## PUBLIC UTILITIES COMMISSION

**RE: Deficiency Report #4 - Certificate of Public Convenience and Necessity for the  
Riverside Transmission Reliability Project – Application No. A.15-04-013**

# DEFICIENCY REPORT #4 FOR THE RIVERSIDE TRANSMISSION RELIABILITY PROJECT APPLICATION (A. 15-04-013)

**CPUC Riverside  
Work Area Constraints  
Mapbook**

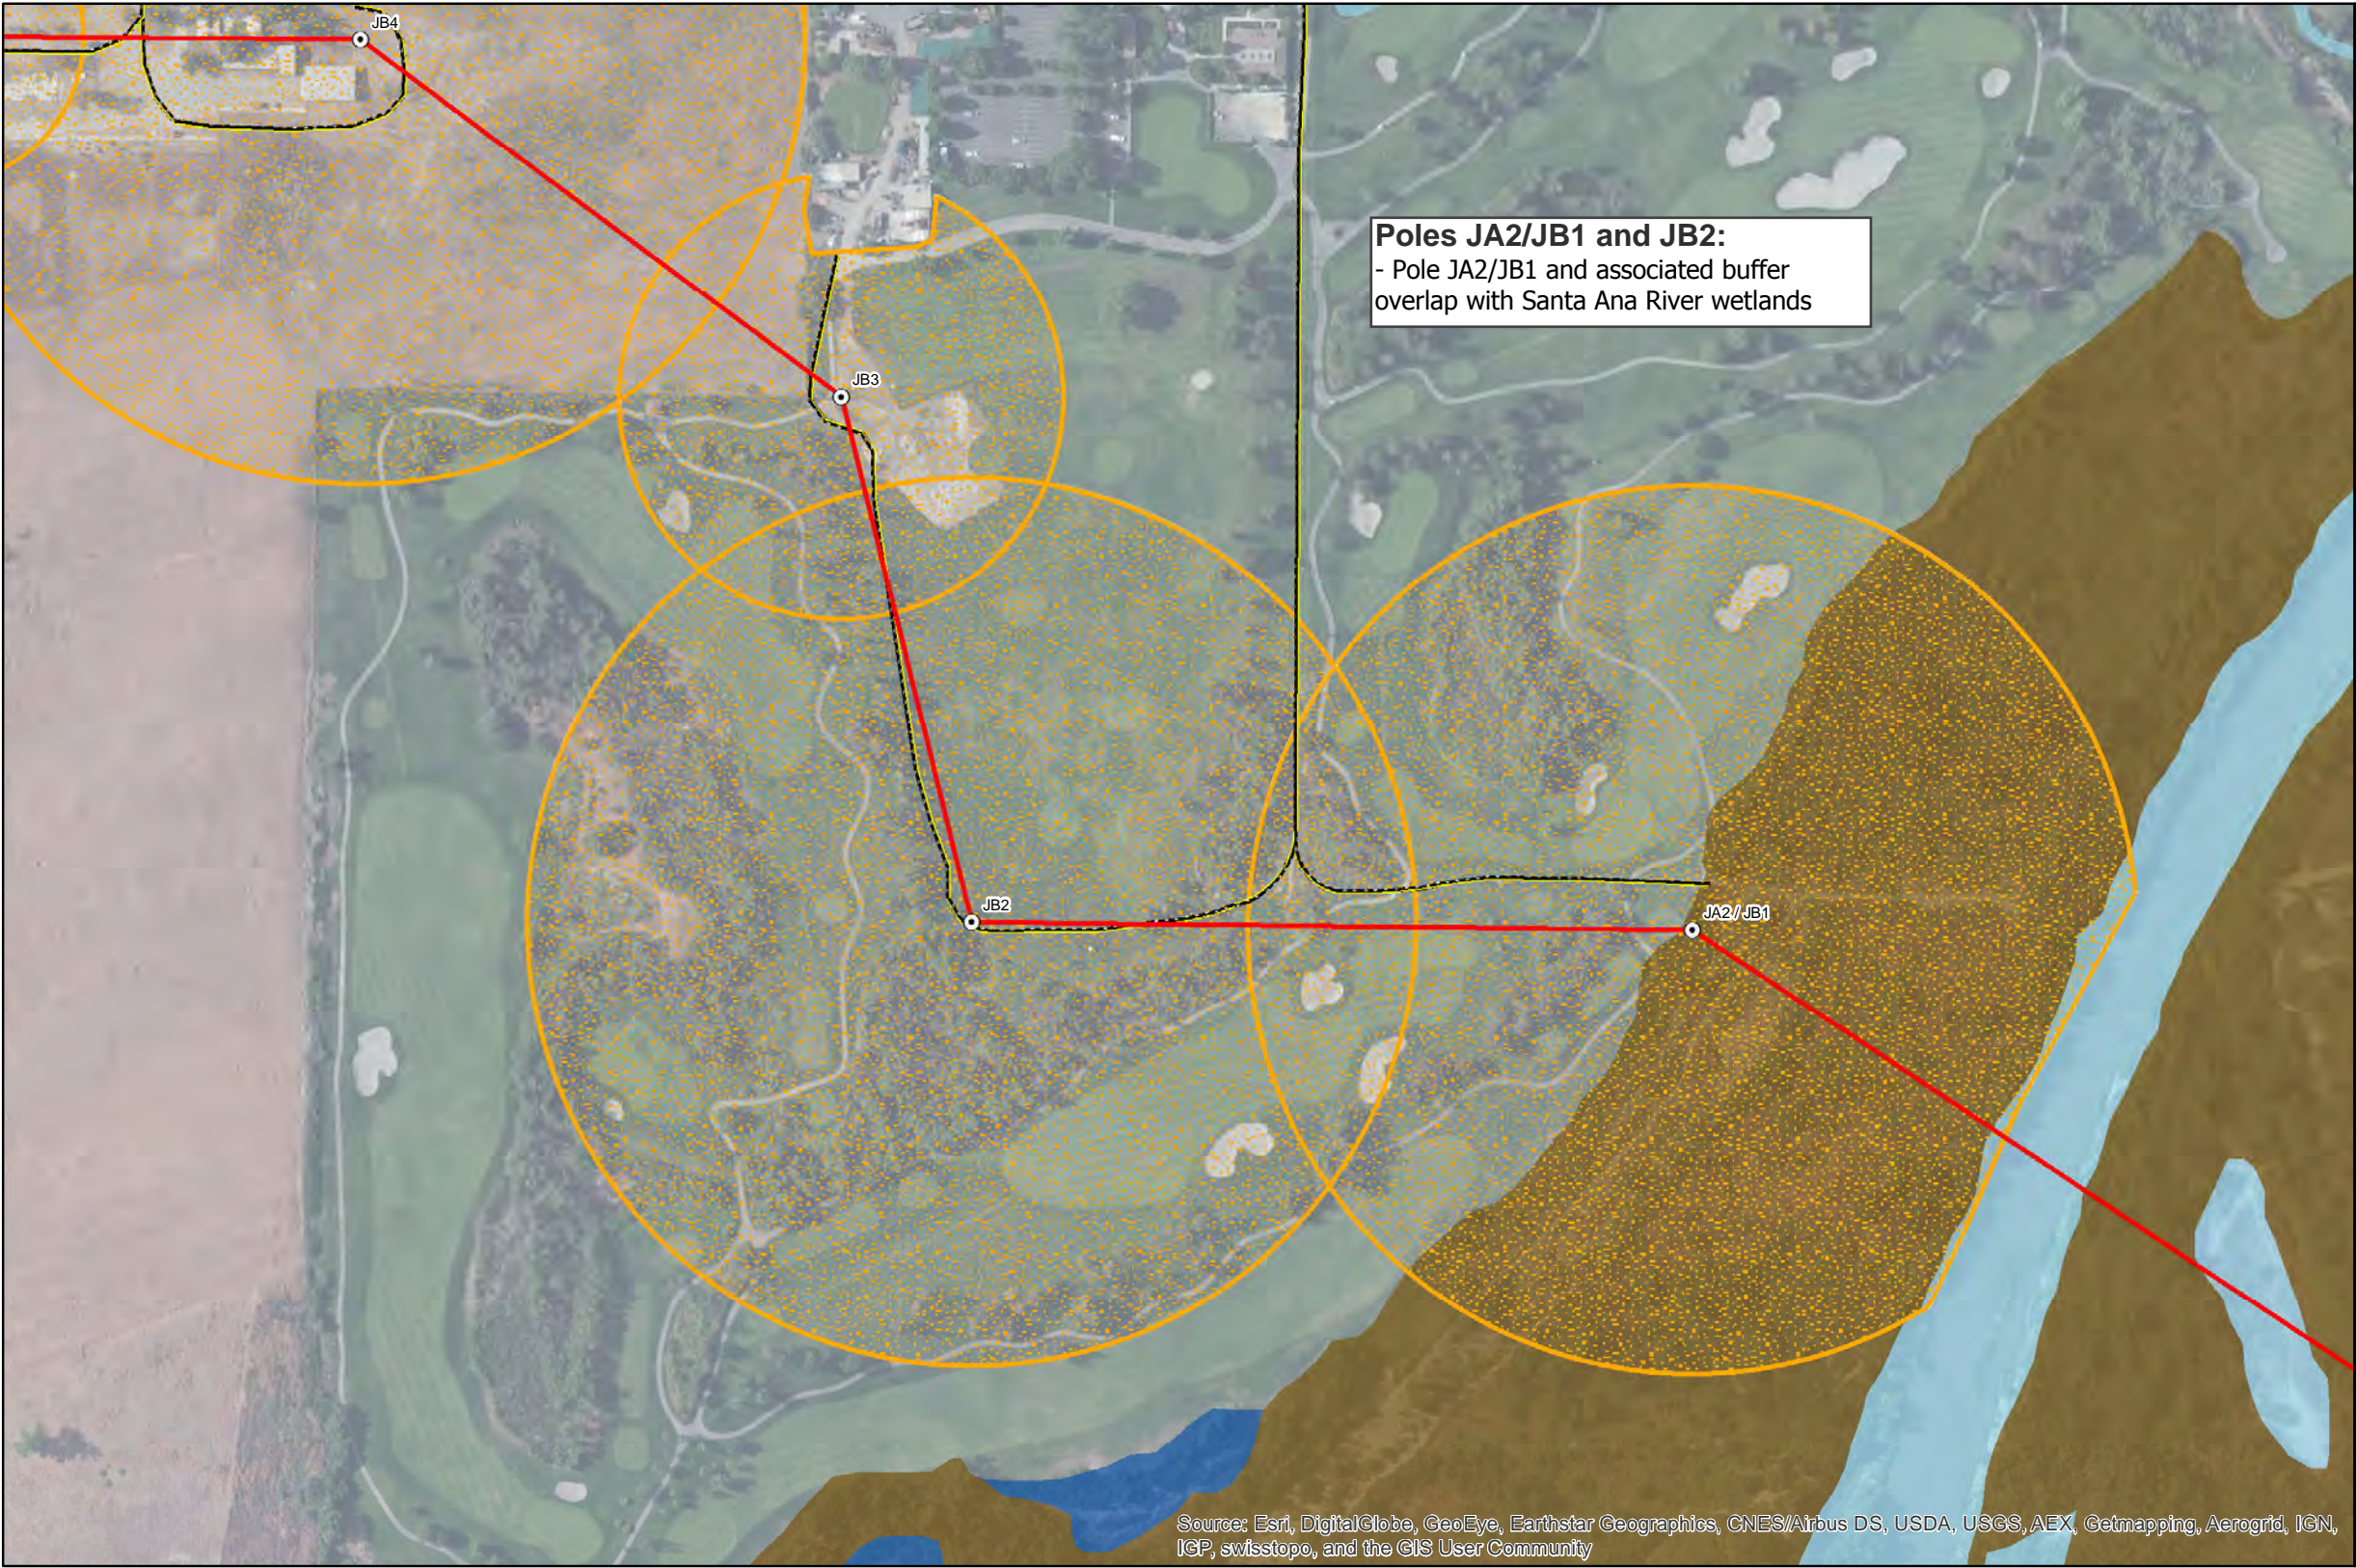
**Poles JA2/JB1 and JB2:**  
- Pole JA2/JB1 and associated buffer  
overlap with Santa Ana River wetlands

Map 11 of 22

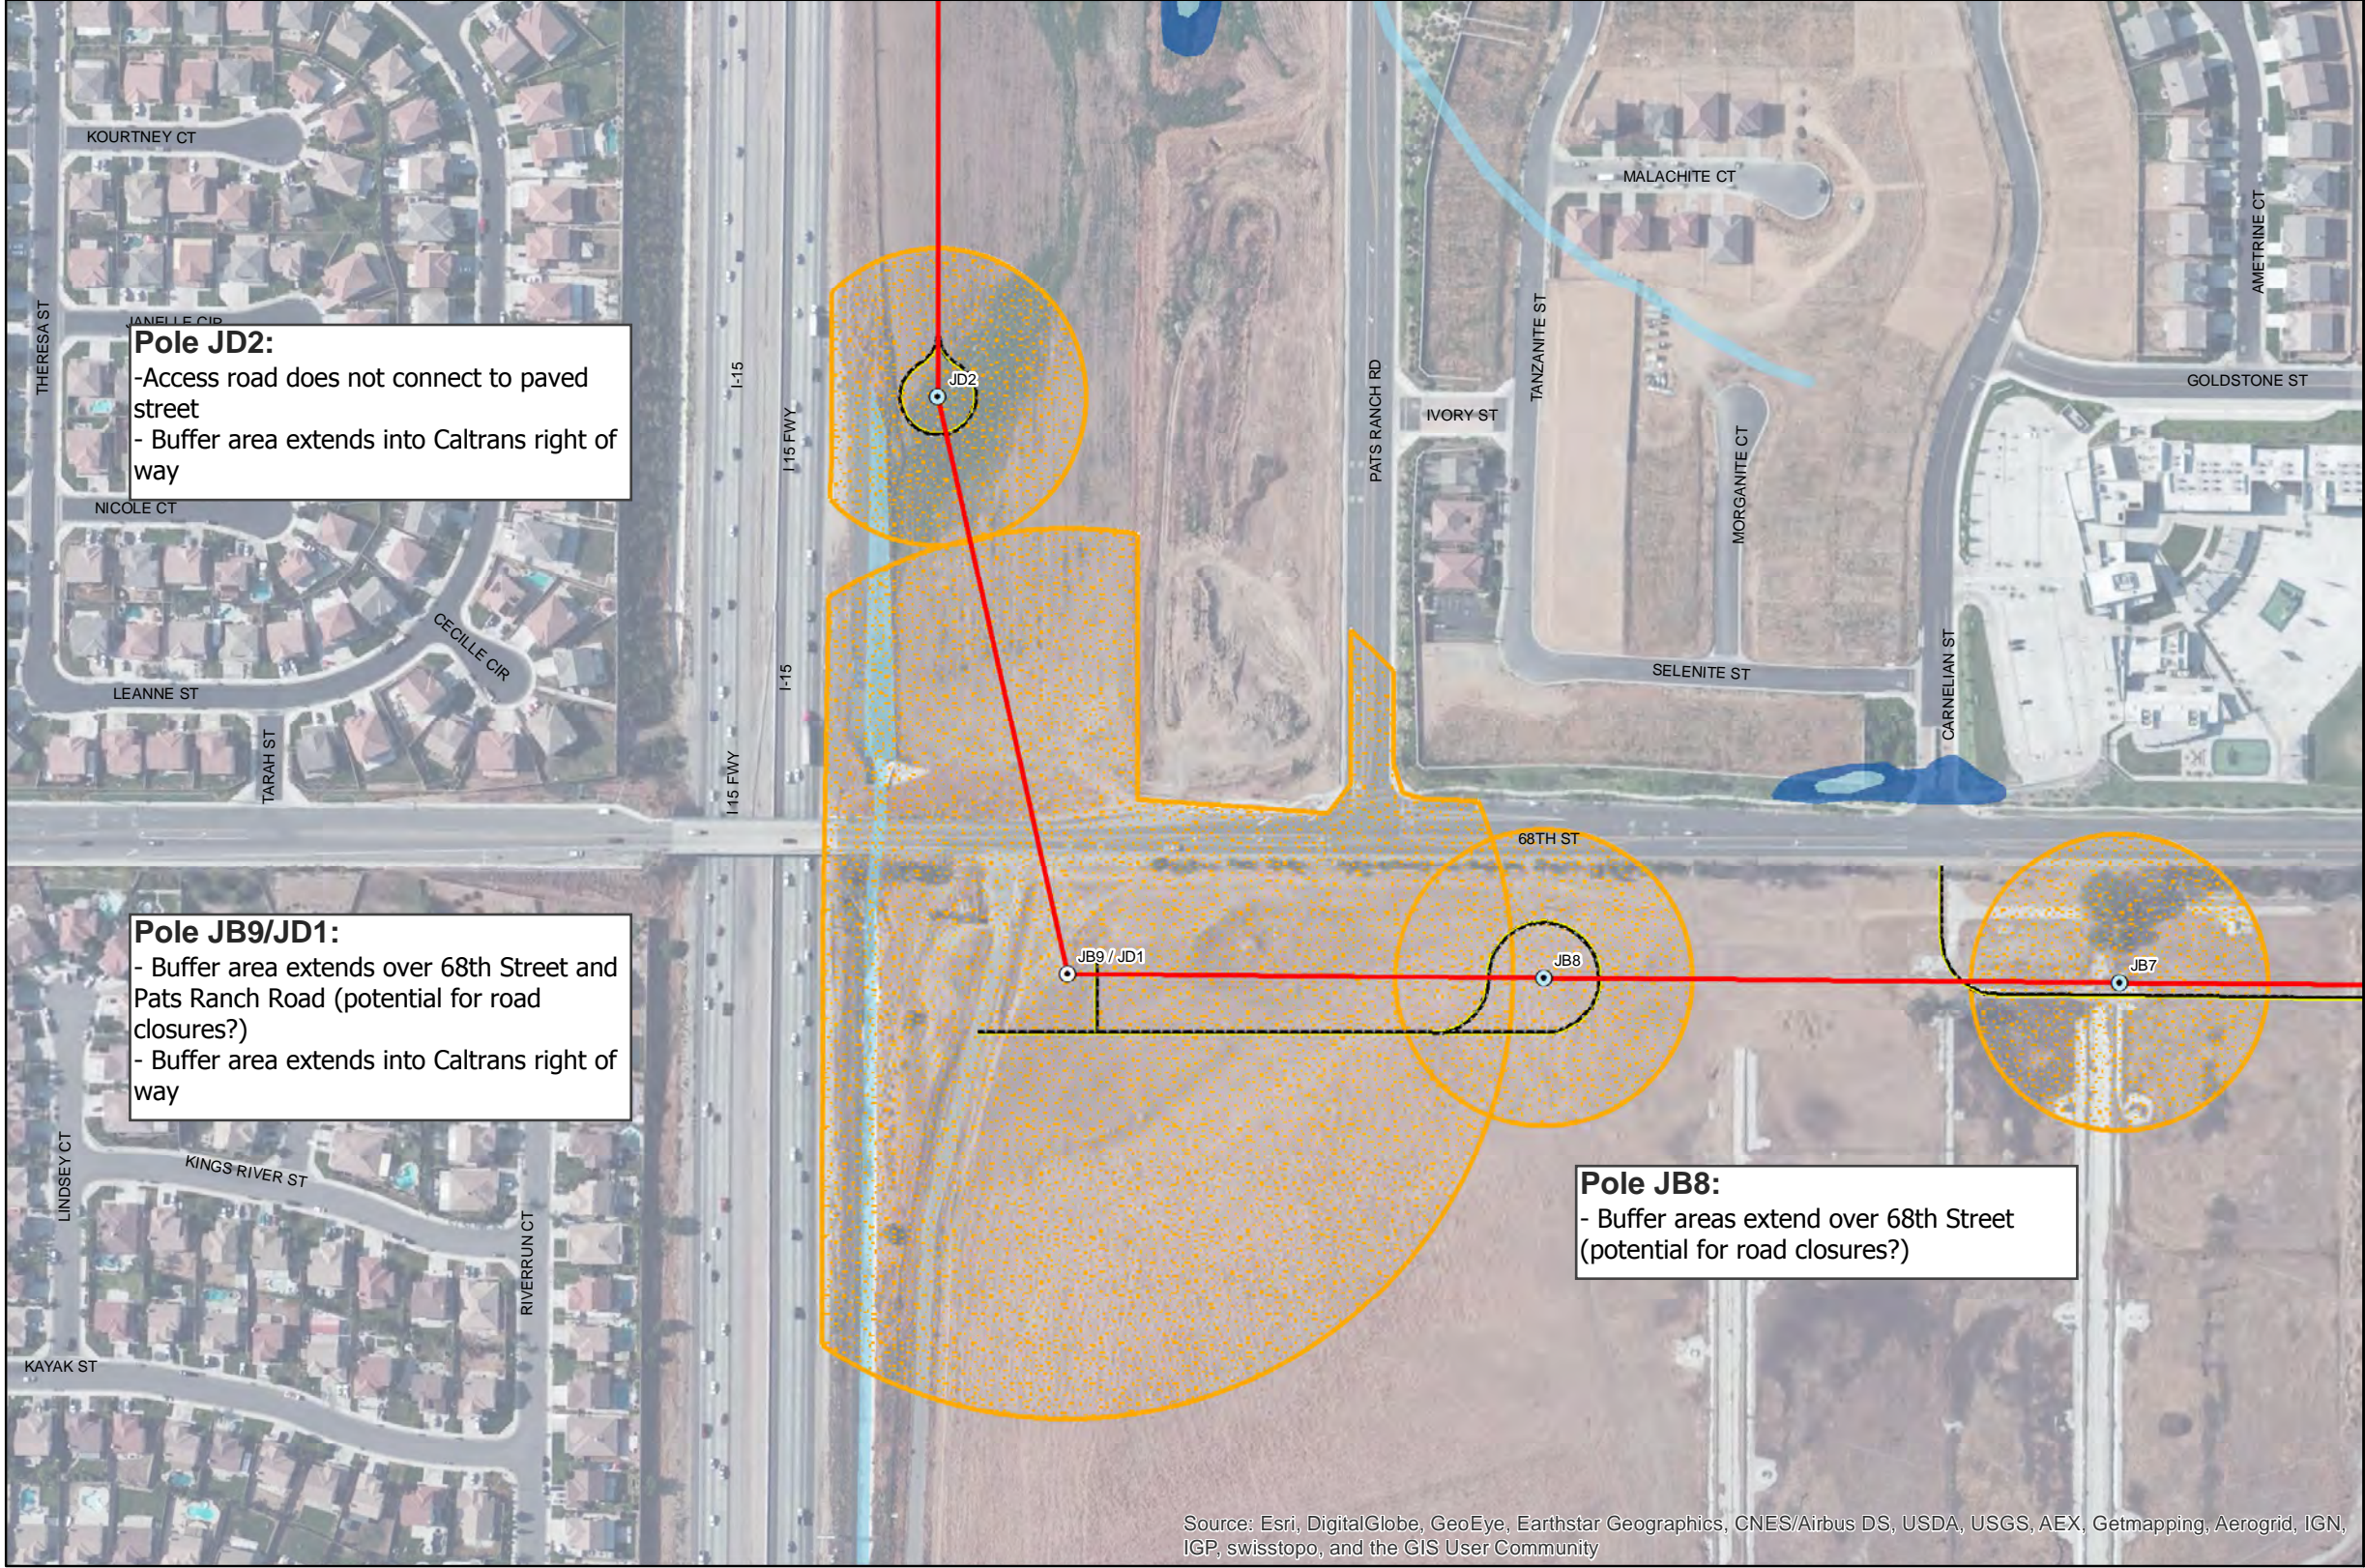
**Pole JD2:**  
-Access road does not connect to paved street  
- Buffer area extends into Caltrans right of way

**Pole JB9/JD1:**  
- Buffer area extends over 68th Street and Pats Ranch Road (potential for road closures?)  
- Buffer area extends into Caltrans right of way

**Pole JB8:**  
- Buffer areas extend over 68th Street (potential for road closures?)

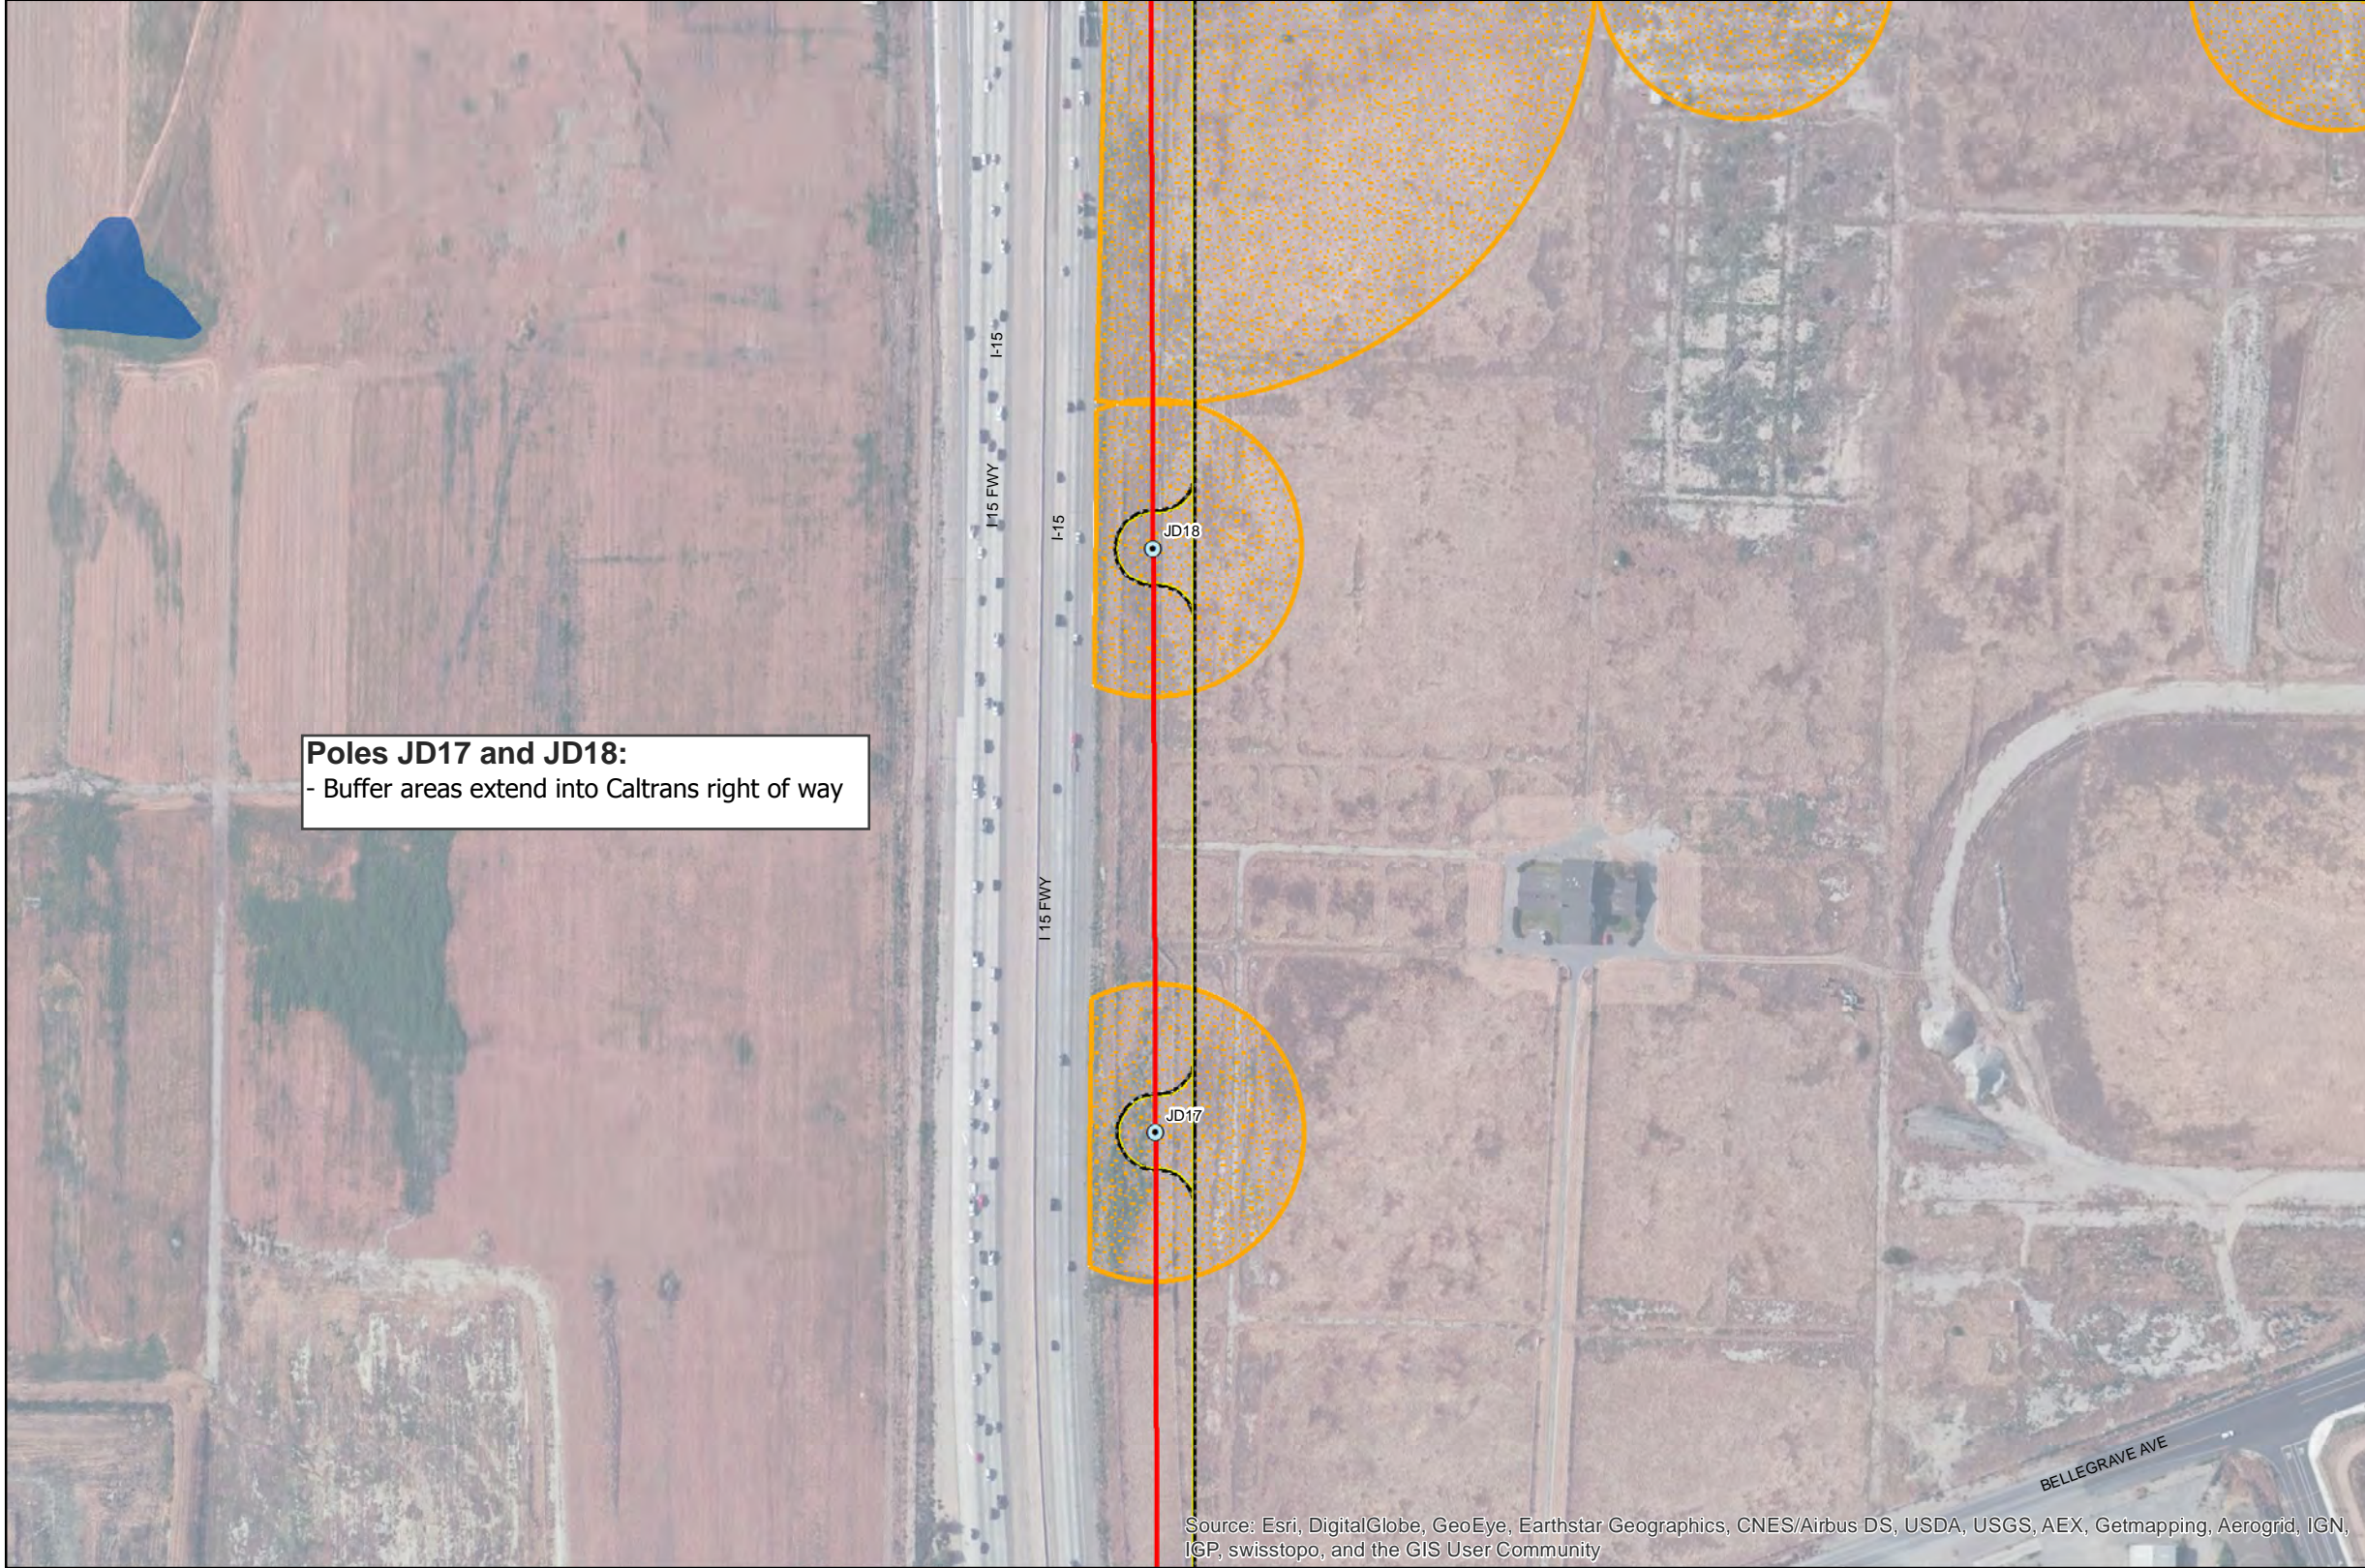
**Pole JD16:**  
- Buffer area extends into Caltrans right of way  
- Buffer area extends into Bellegrave Avenue (potential for road closure?)

**Pole JD15:**  
- Buffer area extends into Caltrans right of way  
- Access to city streets is (Bellegrave Avenue) is not completely shown
